**Subject: Addendum to June 10, 2003 Excavation Plan  
Enterprise Recycling & Disposal Facility  
Angelo's Aggregate Materials, Ltd.  
FDEP Permit Nos. 177982-001-SC, 177982-002-SO  
Pasco County, Florida**

**Subject: Enterprise Recycling & Disposal Facility  
Angelo's Aggregate Materials, Ltd.  
FDEP Permit Nos. 177982-001-SC, 177982-002-SO  
Pasco County, Florida**

**From:** Ford, Kim  
**Sent:** Thursday, June 19, 2003 3:38 PM  
**To:** Pelz, Susan; Morris, John R.  
**Subject:** conversation with Jennifer Deal about Enterprise CIII

**PIEZOMETER AND BORING LOCATION MAP  
PROPOSED ENTERPRISE RECYCLING AND DISPOSAL FACILITY  
DADE CITY, FLORIDA**

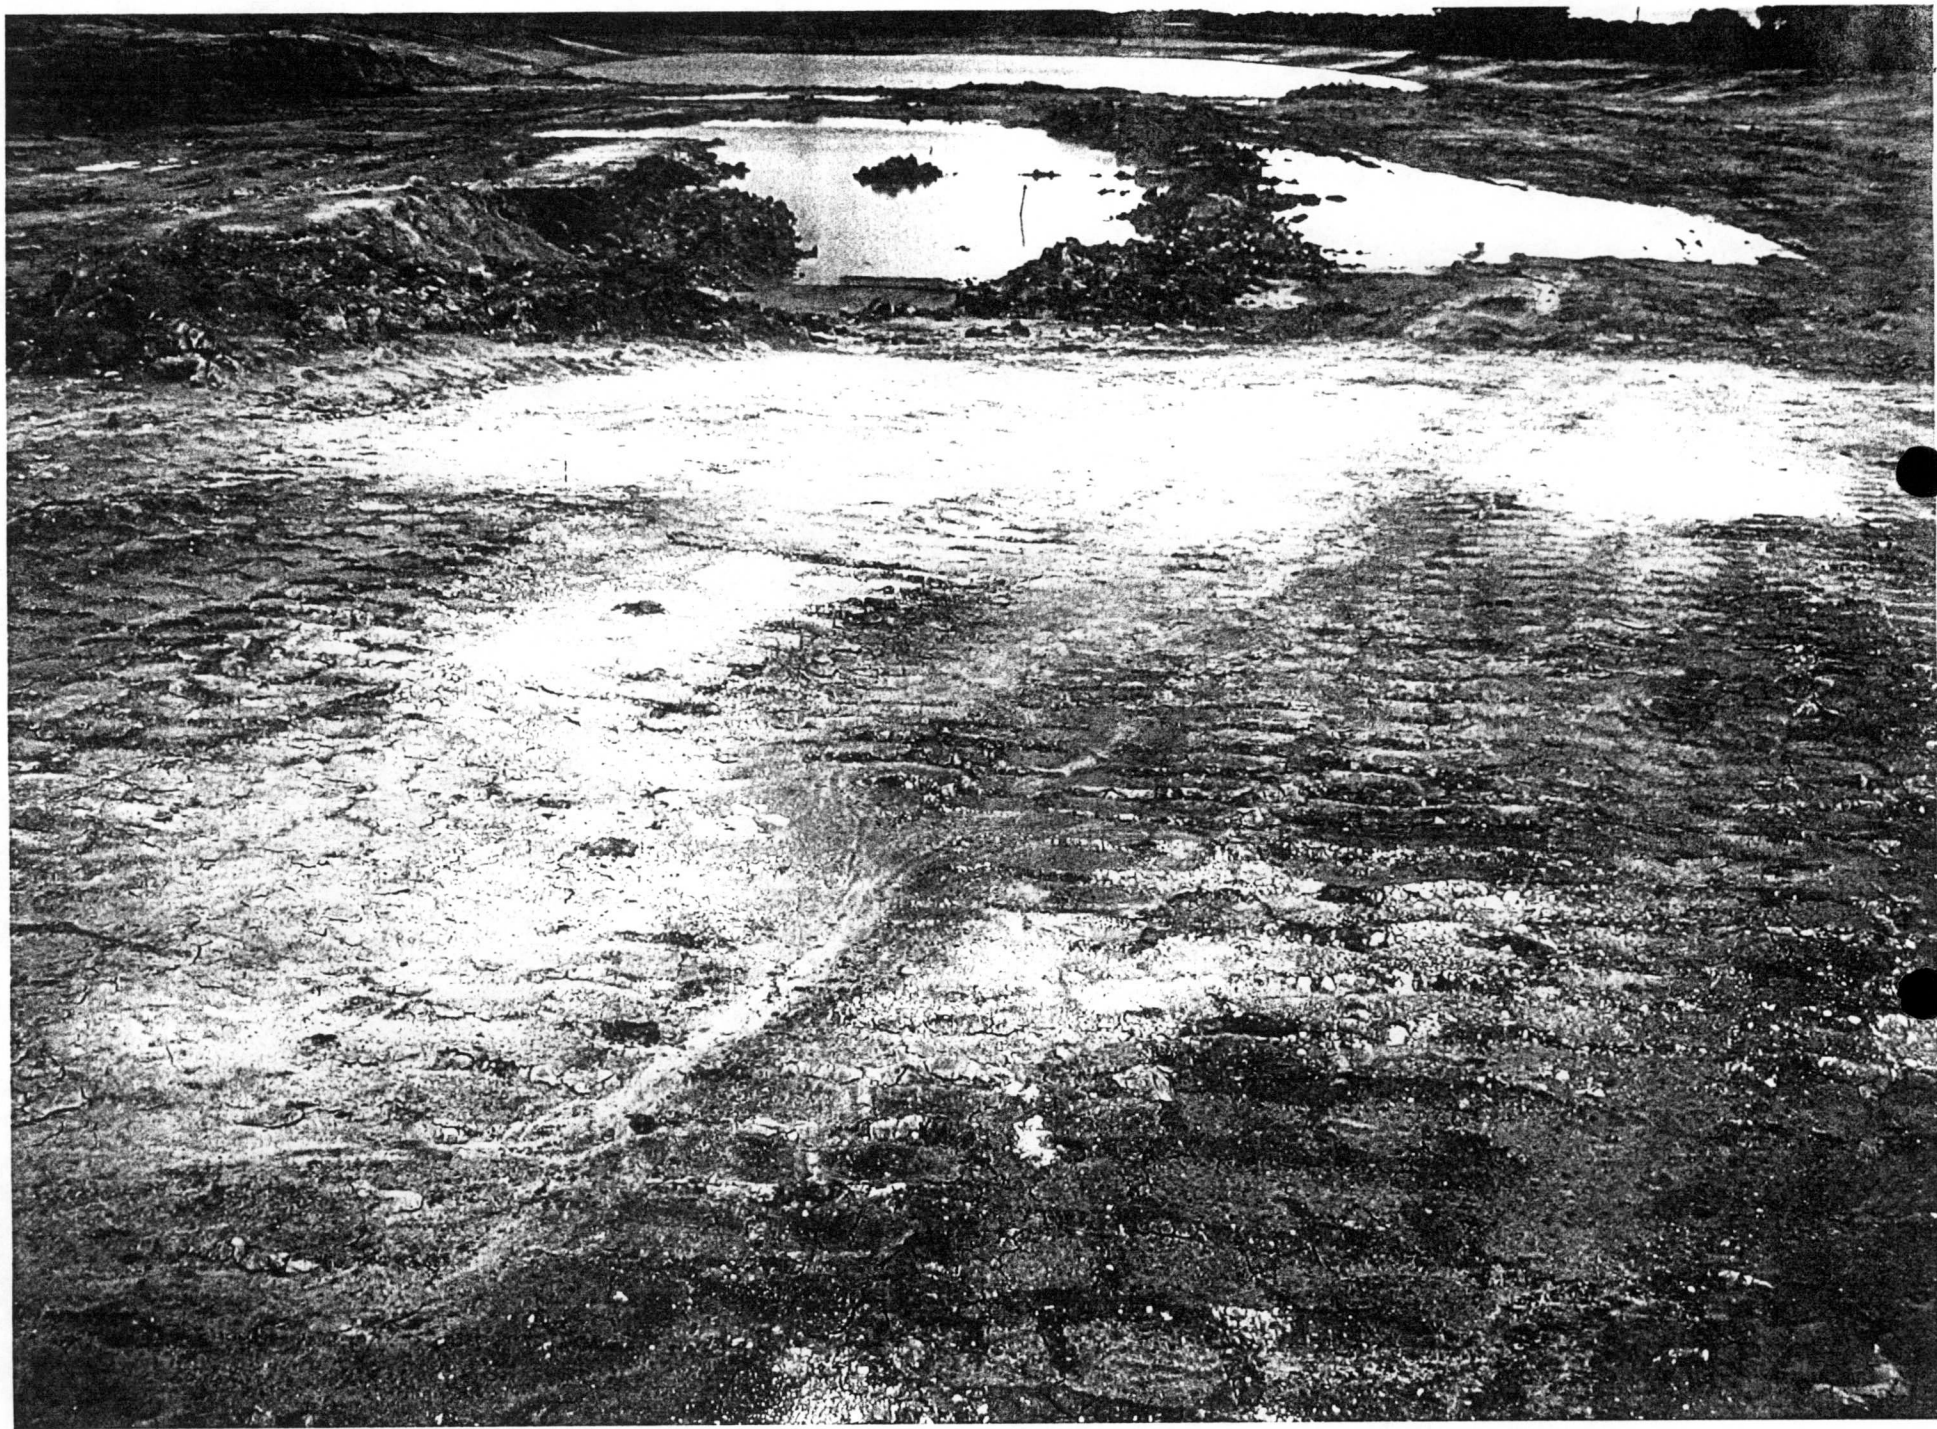
4. use Sheet C-2 for the base grades maybe enlarge the cell 1 part of the sheet to 1" = 100' or 1' = 50', and show all elevations on that drawing as part of the weekly report

5. a cross-section N-S along the east new wells is needed for geology of the area
6. water levels requested as part of each weekly report for all wells and PZs

FIGURE  
4

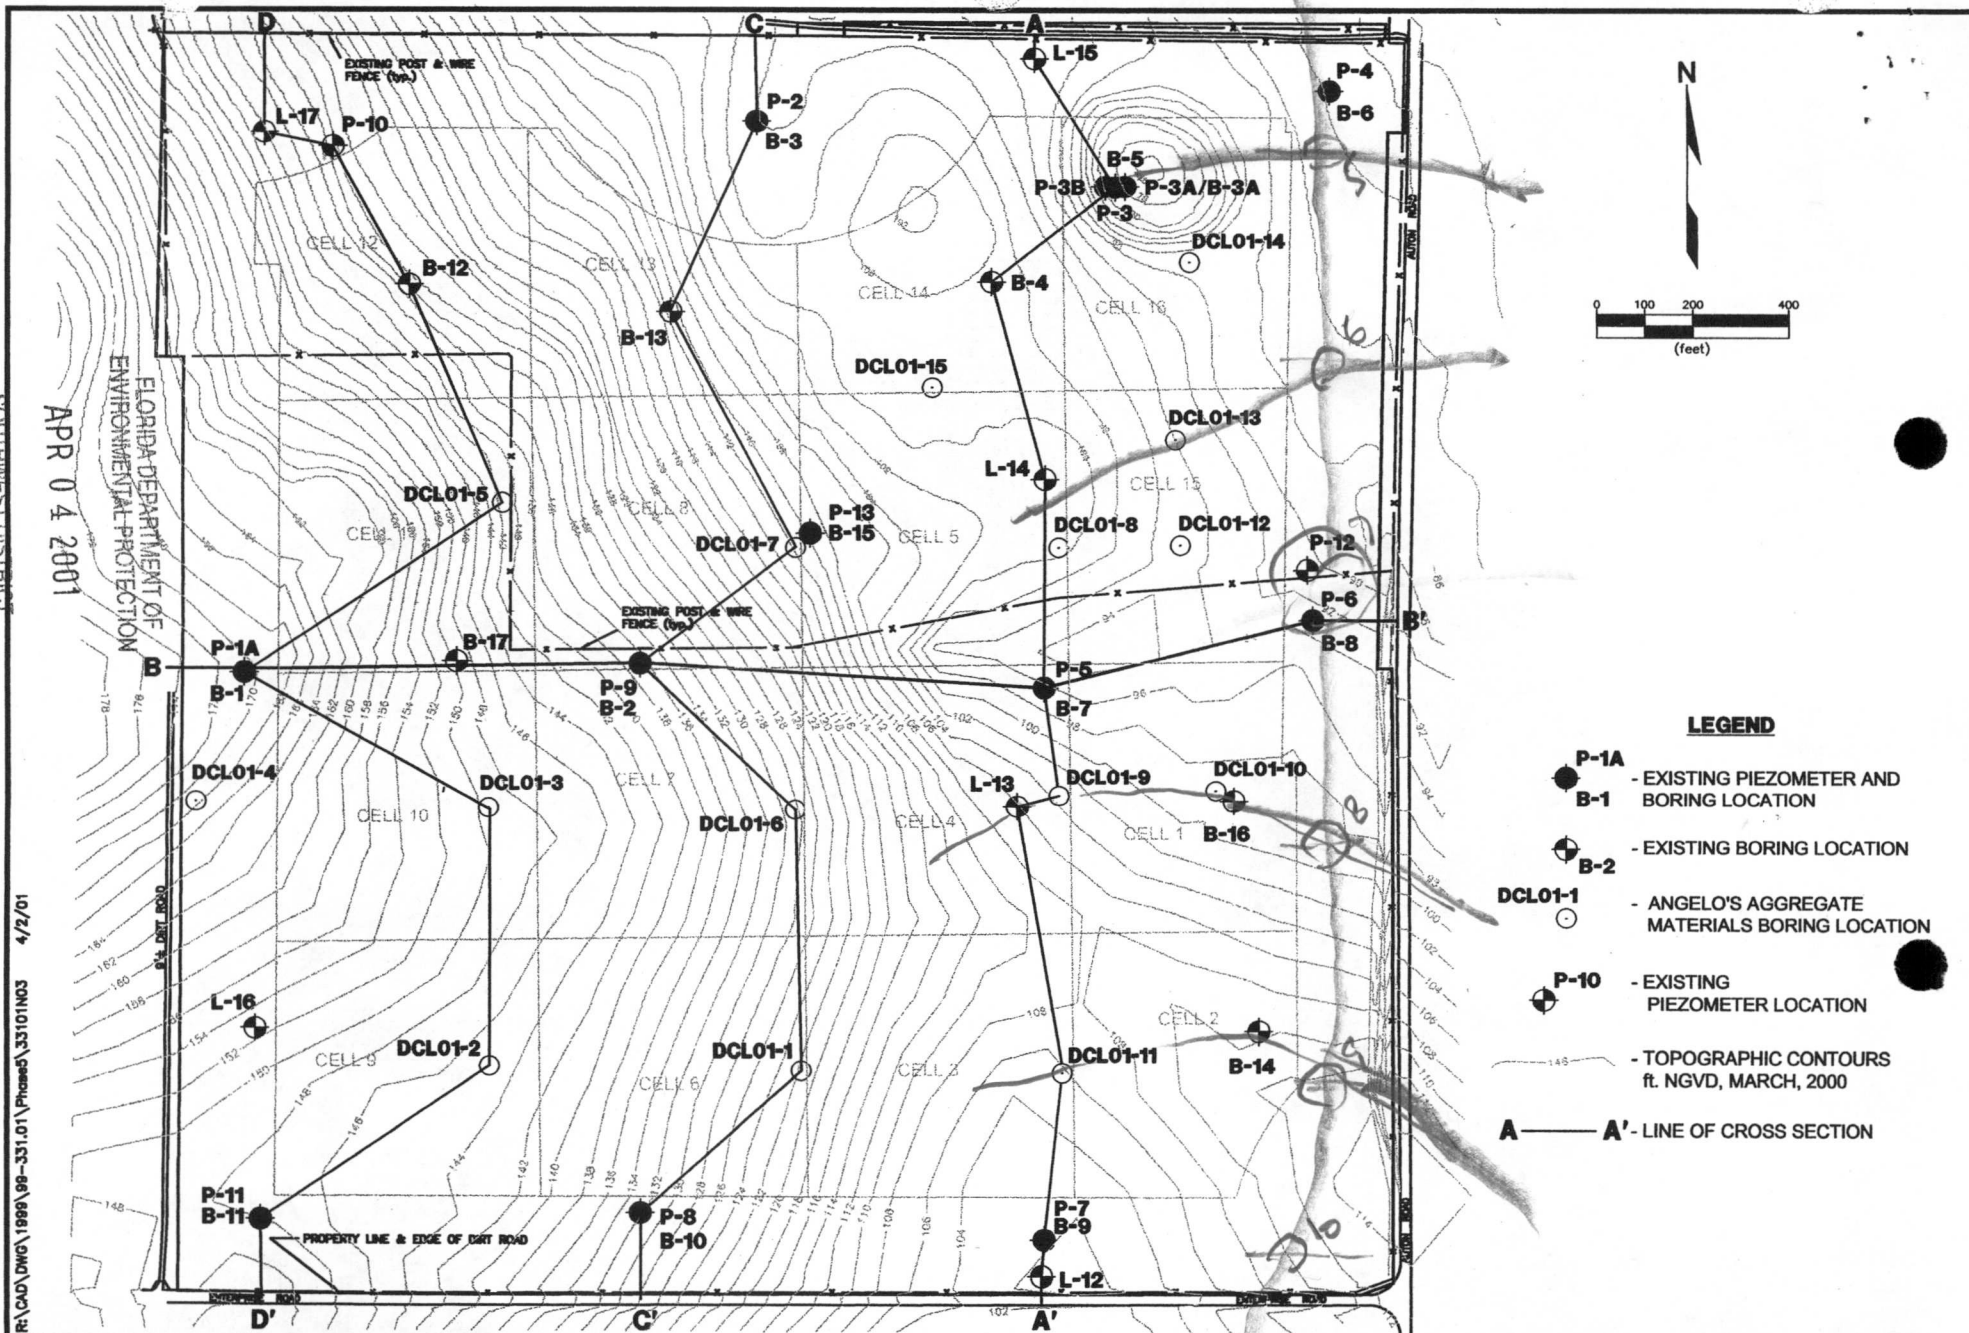
- \* also discussed proposed stormwater Pond 2 (west boundary) and Pond 3 (north boundary); the site map attached to the operating permit (# 177982-002-SO) appears to indicate that proposed well MW-8 and gas probe GP-10 may be located within Pond 2; it also appears that proposed well MW-3 and gas probe GP-6 may be located within Pond 3; need to consider relocating these wells/gas probes prior to their installation to minimize impacts with the stormwater ponds
